Denial Memorandum

Applicant: John Timoni and Michele Leiro
Address: 105 South Ward Avenue, Rumson, NJ 07760
Block 139, Lot 22, Zone: R-5

I have reviewed the revised Land Use & Development Permit application for improvements at 105 South Ward Avenue in Rumson. This review is based on the latest architectural revision dated June 10, 2026.

PLOT PLAN
Scale: 1/16"=1'-0"

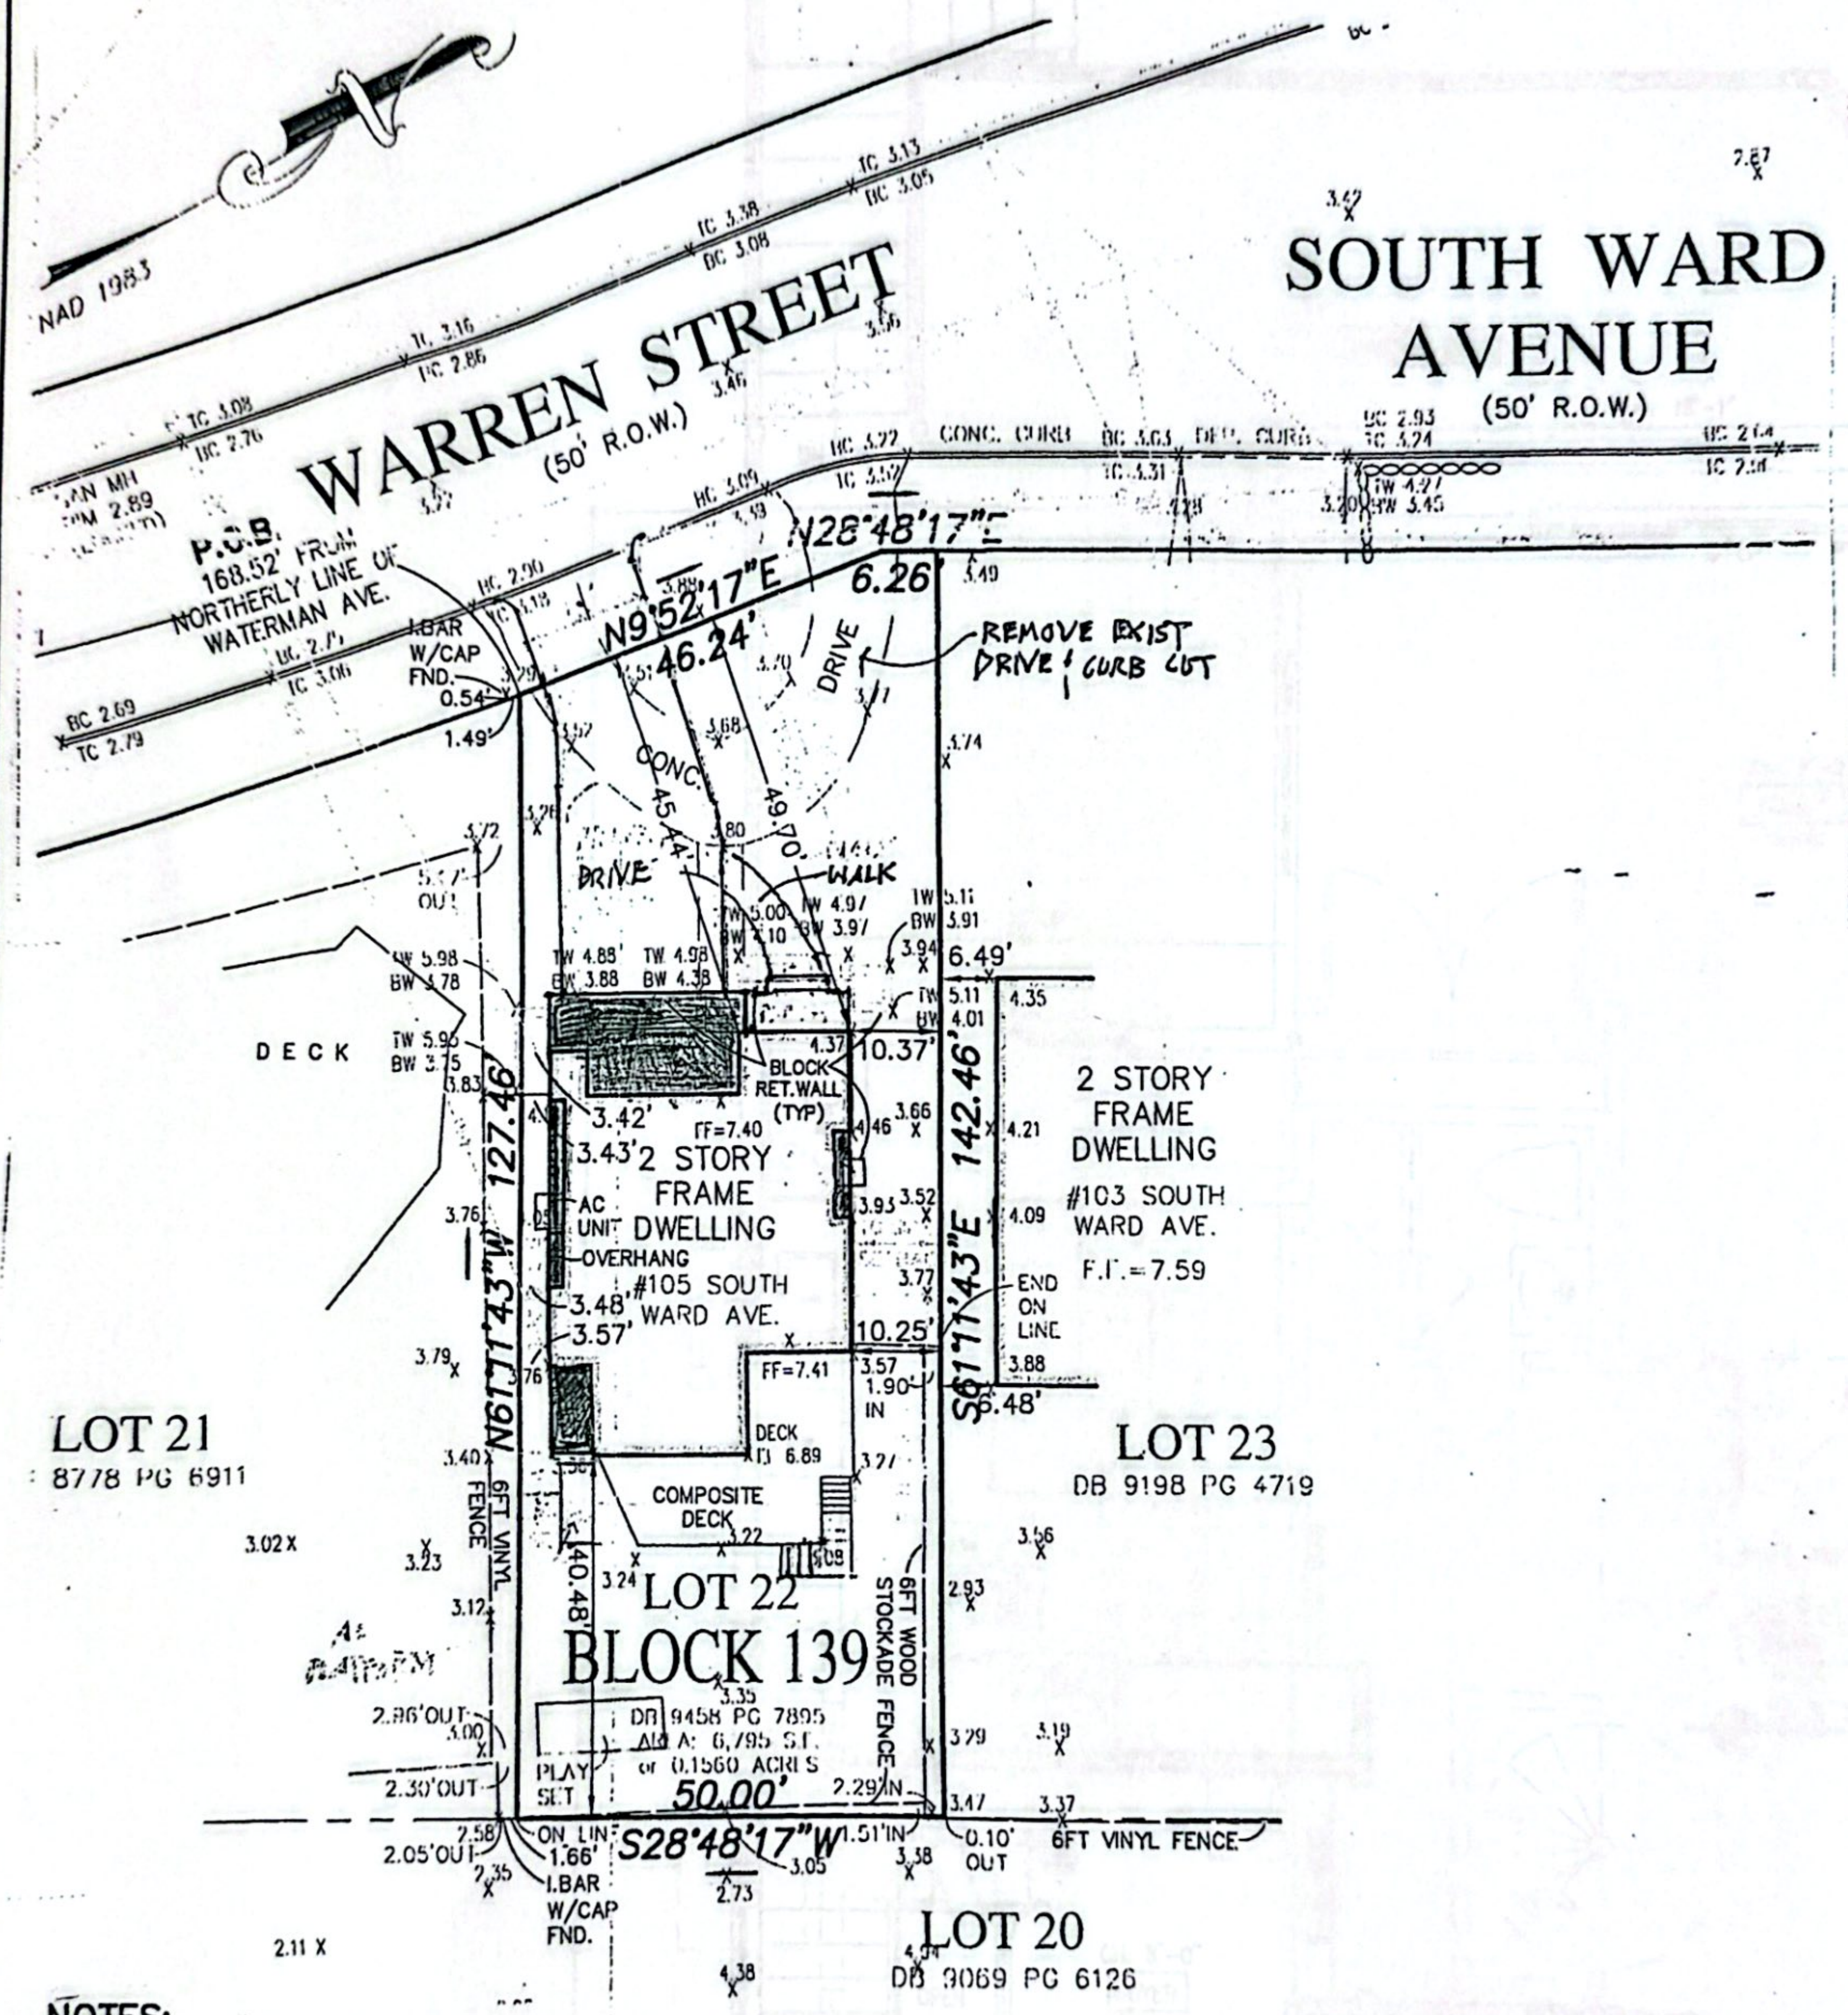
- Proposed Floor Area of 3,497 SF, whereas 2,538.5 SF is permitted, and 2,525 SF currently exists. **(Sched 5-3 New, 38% over)**
- Proposed Building Coverage of (1,782) SF, whereas 1,499 SF is permitted. 1,351 SF currently exists. **(Sched 5-4 New)**

- *Note: The Zoning chart lists the building coverage as 1,741-sf, the calculations show 1,782-sf.*
- Lot depth (Borough definition) is 130'.
 - The proposed rear raised deck with rear setback of 30.4' whereas 39' is required. **(Sched 5-1 New)**

- Entry steps in a flood zone are permitted to extend an additional 5' in the RYSB. Proposed rear steps setback at 27.4', whereas 34' is required. **(Sched 5-1 New)**

- *Note: The zoning chart identifies the proposed rear yard setback as 40.88 feet; however, the correct setback to the proposed deck is 30.44 feet, where 39 feet is required. The proposed steps are located 27.4 feet from the rear property line, where 34 feet is required.*
